Project	<b>IEEE 802.16 Broadband Wireless Access Working Group</b> < <a href="http://ieee802.org/16">http://ieee802.org/16</a> >	
Title	<b>Frame Alignment Requirement in Relays</b>	
Date Submitted	<b>2007-01-17</b>	
Source(s)	Gamini Senarath, Hang Zhang, Peiying Zhu, Mo-Han Fong, Wen Tong, Israfil Bahceci, David Steer, Derek Yu, Mark Naden, G.Q. Wang	Voice: +1 613 7631315 [mailto:WenTong@nortel.com] [mailto:pyzhu@nortel.com]
	Nortel 3500 Carling Avenue Ottawa, Ontario K2H 8E9  Wendy C Wong Jerry Sydir Hyunjeong Hannah Lee Kerstin Johnsson Intel Corporation 2200 Mission College Blvd.,  Santa Clara, CA 95054, USA	(wendy.c.wong@intel.com) (jerry.sydir@intel.com)
Re:	A response to a Call for Technical Proposal, <a href="http://wirelessman.org/relay/docs/80216j-06_034.pdf">http://wirelessman.org/relay/docs/80216j-06_034.pdf</a>	
Abstract	The relay has an additional requirement of aligning its downlink transmissions with the BS compared to the MS alignment requirement in 802.16e. Since relay is re-transmitting the preamble and data to its mobiles this is required to avoid deterioration of performance. In addition, a relay may obtain sync from another relay thus any misalignment could acc

Figure XXX: An Illustration of the frame alignment requirement for the relays

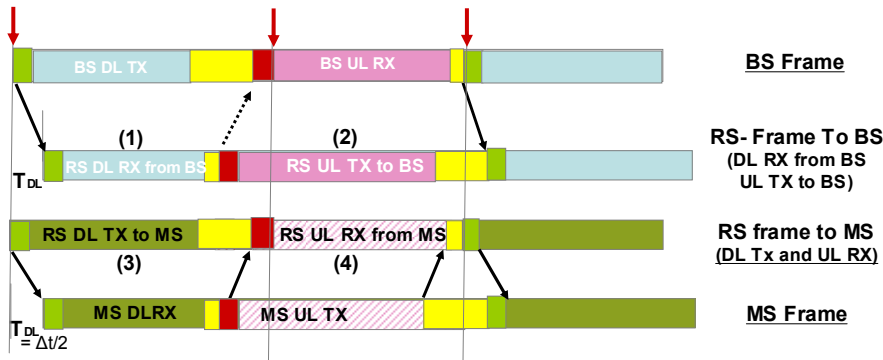
In order to achieve proper operation, the relay downlink transmission to its children (RS or MS) should be time-aligned with the MR-BS's downlink transmission to its children (RS or MS).

For the TDD mode, an example of an RS frame structure is shown in Figure <xxx>.

Note: RS rx and RS tx may not happen in the same time. They happen in different zones. But this diagram is only to show that how the frames are aligned.

- Frame (1) is  $T_{DL}$  duration delayed and Frame (2) is  $T_{UL}$  duration advanced relative to the BS frames.
- Frame (3) is fully aligned with BS TX and Frame (4) is fully aligned with BS RX.
